ORE - TRAFFIC: Jan 2026 Proposed TEM Updates Summary

Each proposed revision (row below) is bookmarked in the document

Arch - Single Lane

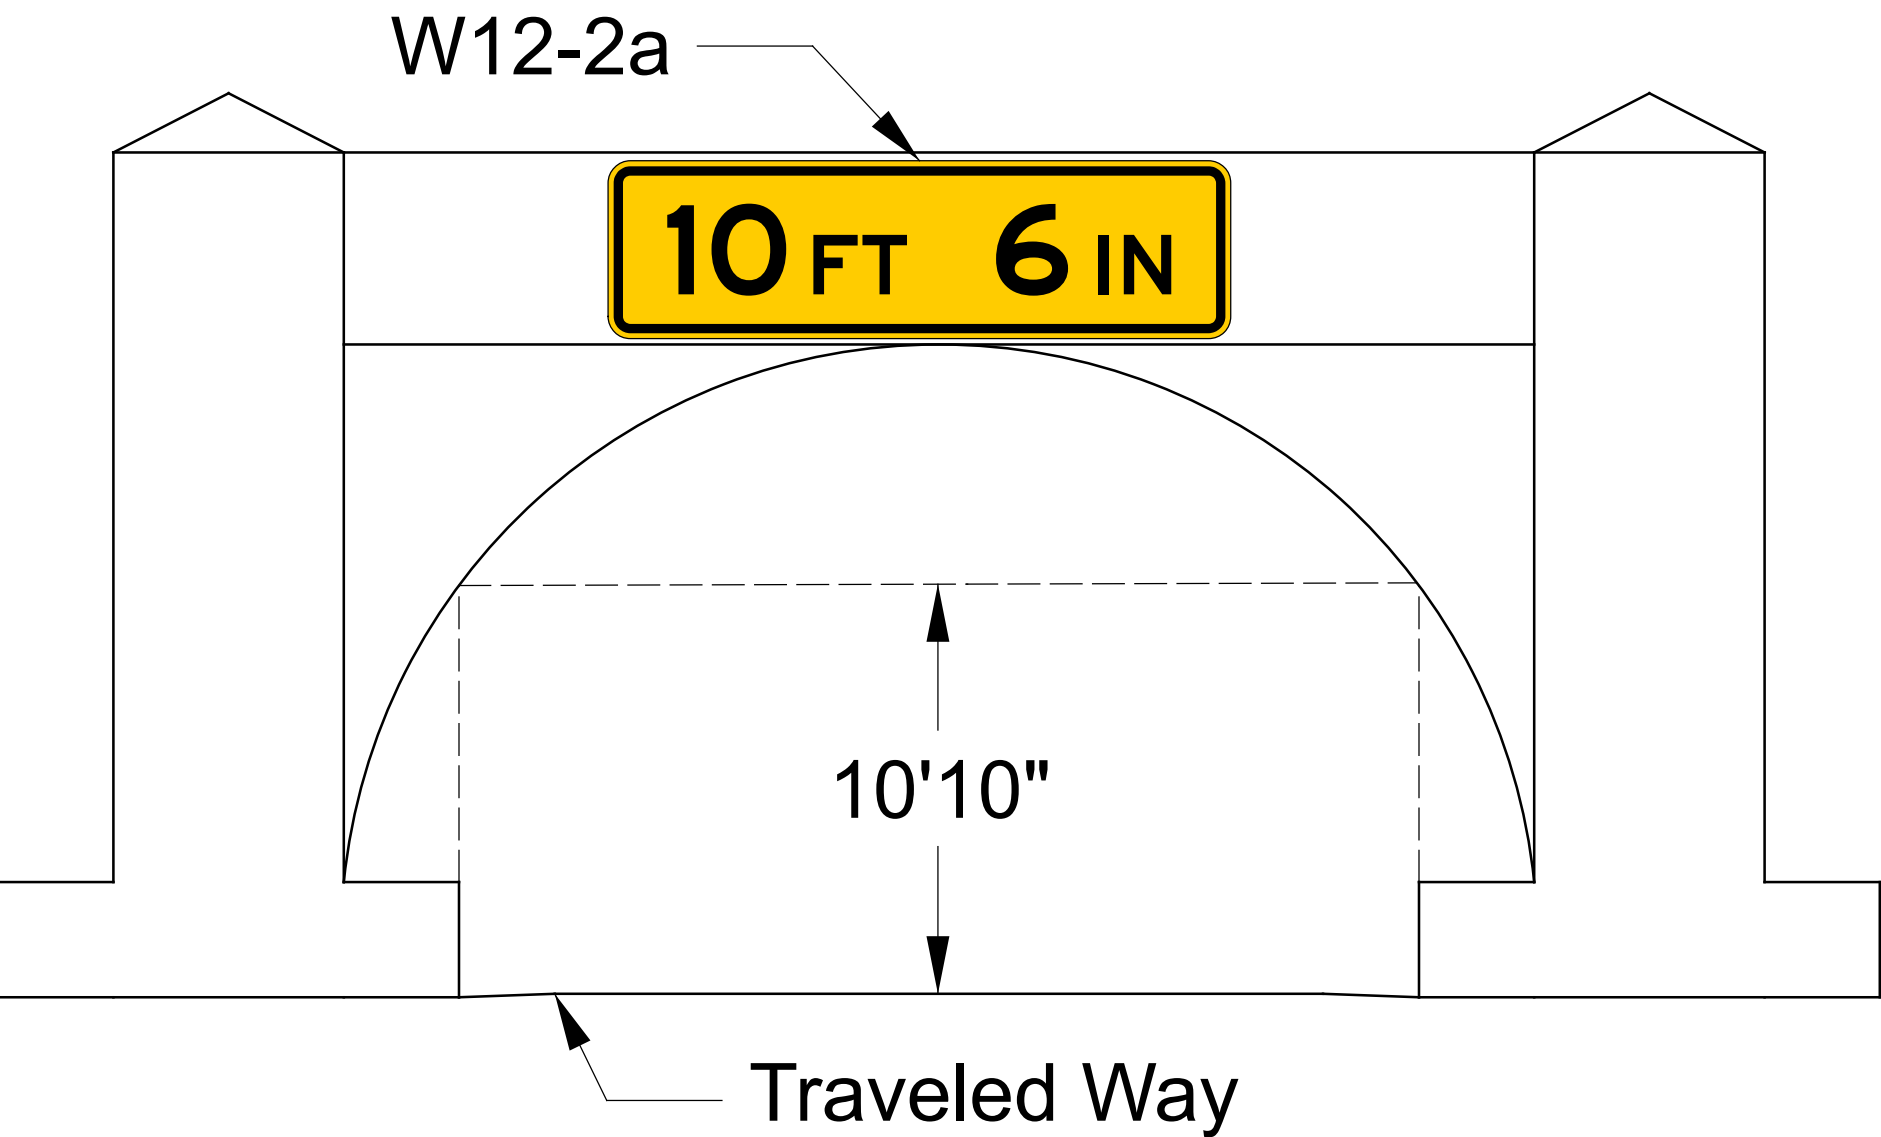
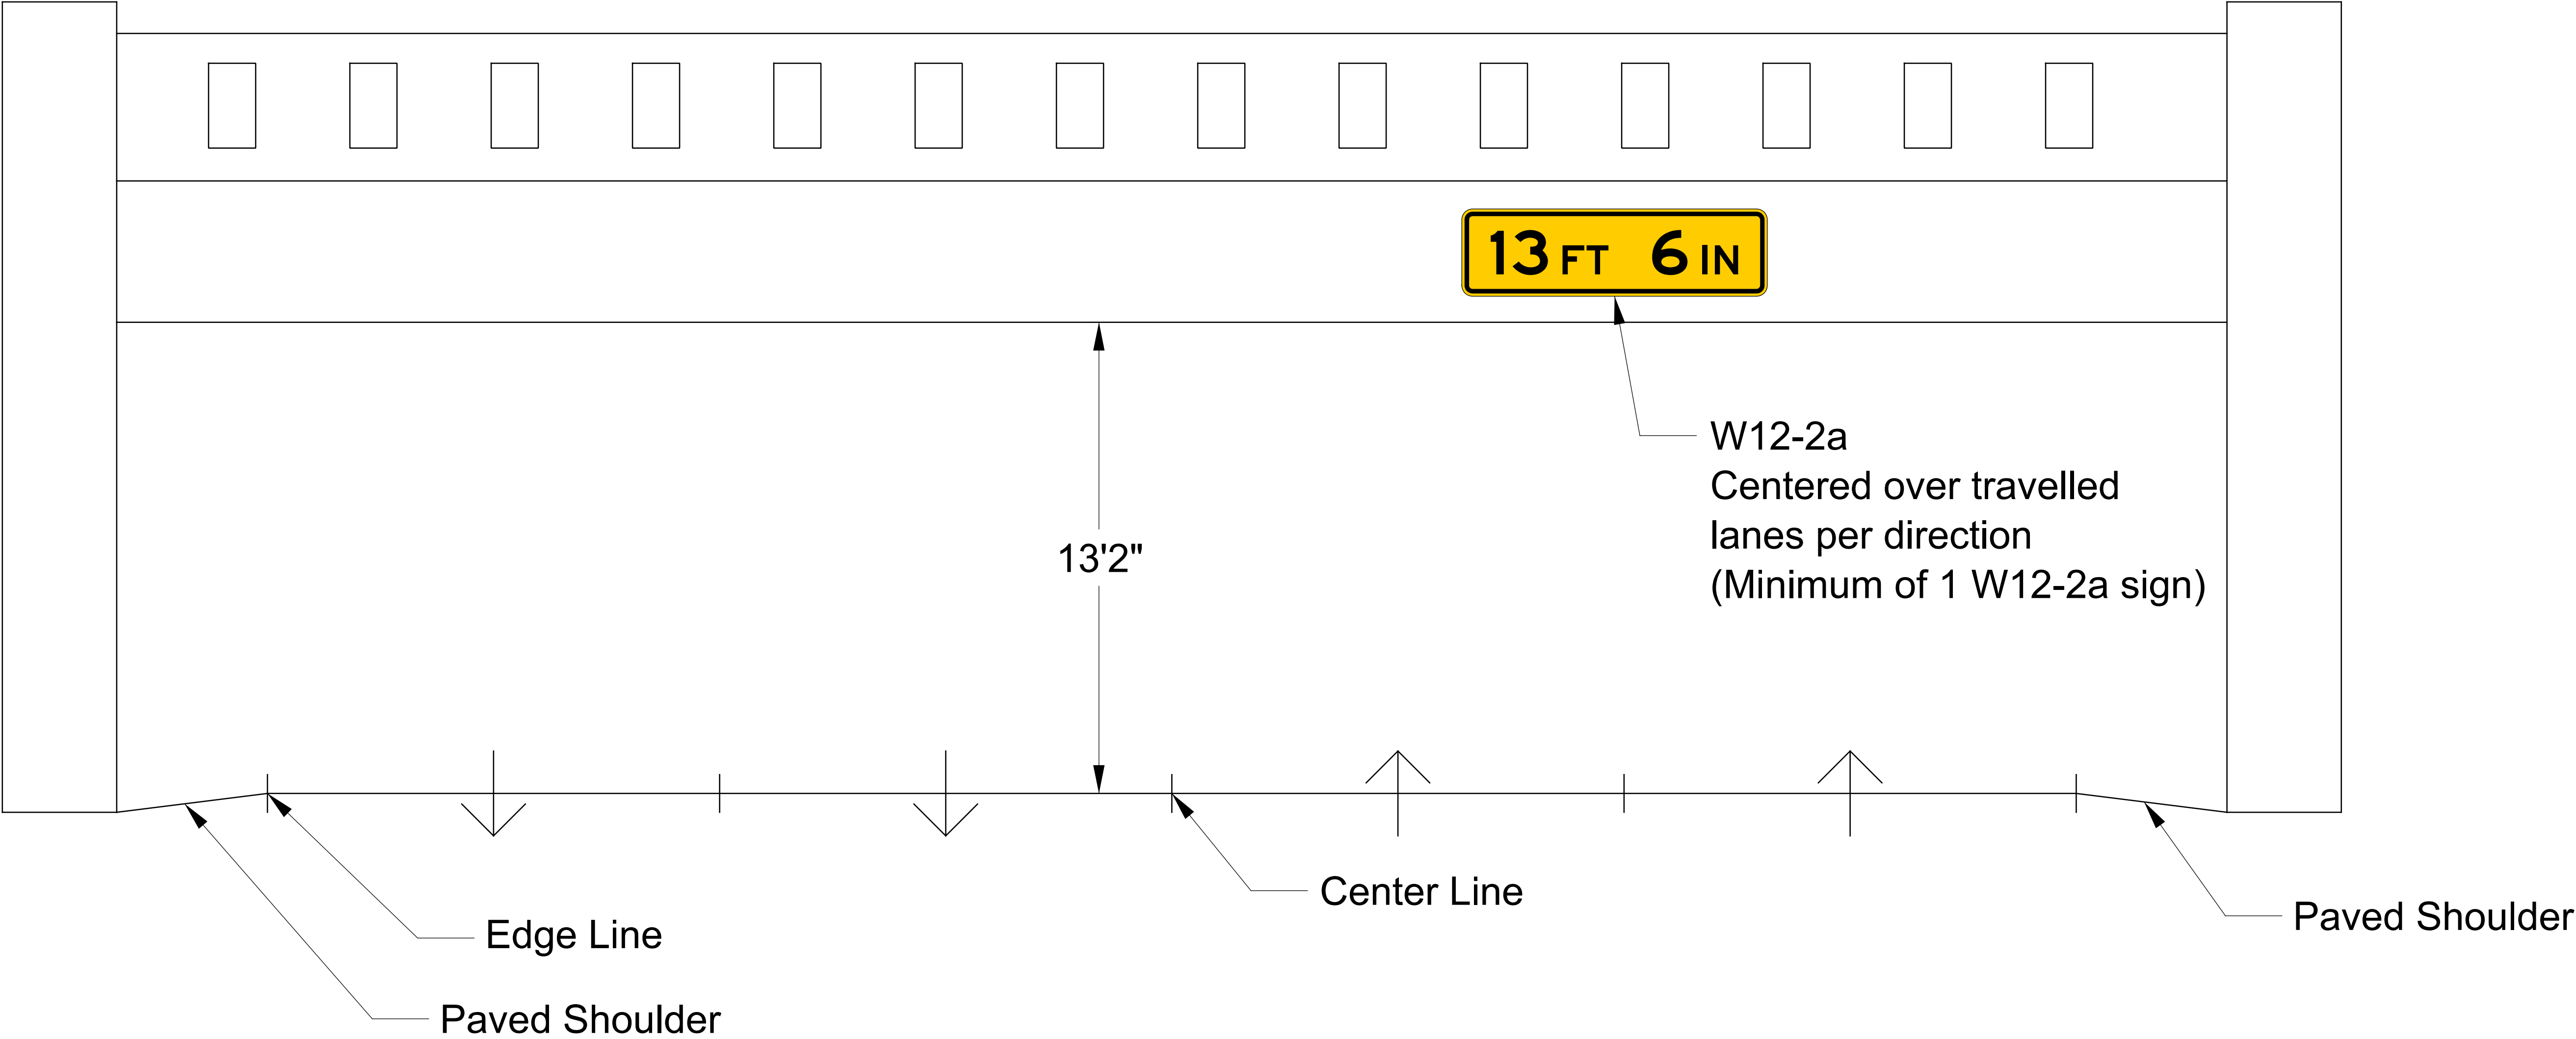
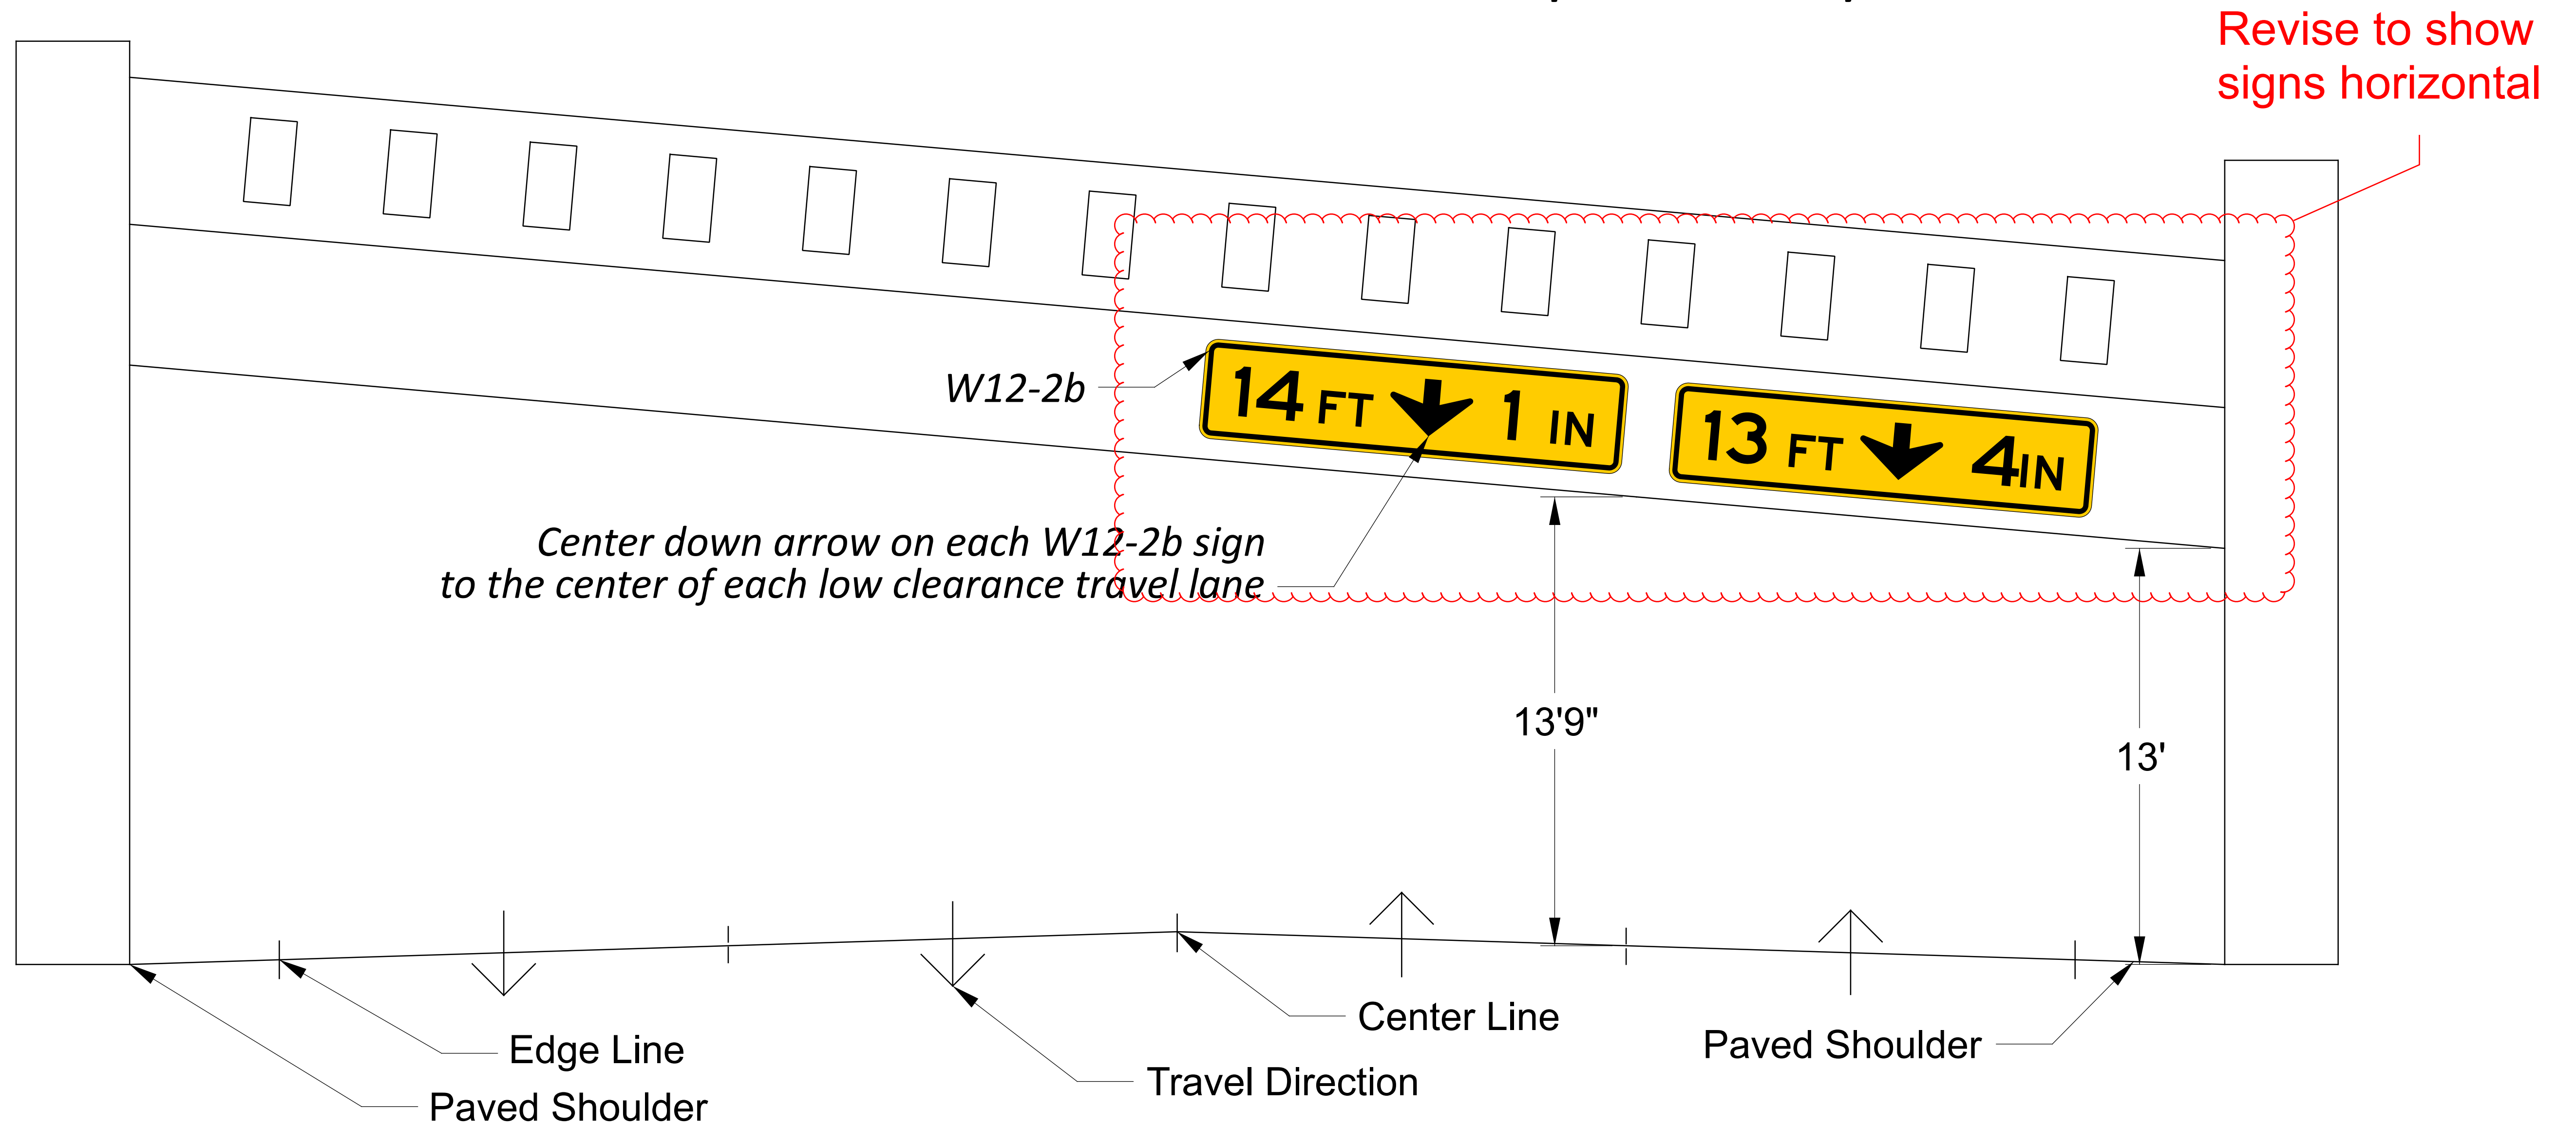
Added Additional bridge
posting layouts, and
Examples of signs being
posted on freeways and
conventional routes

NOTE:
All Low Clearance Signs displayed on bridge
use a 4" buffer from the actual low vertical
clearance (Actual Height - 4")
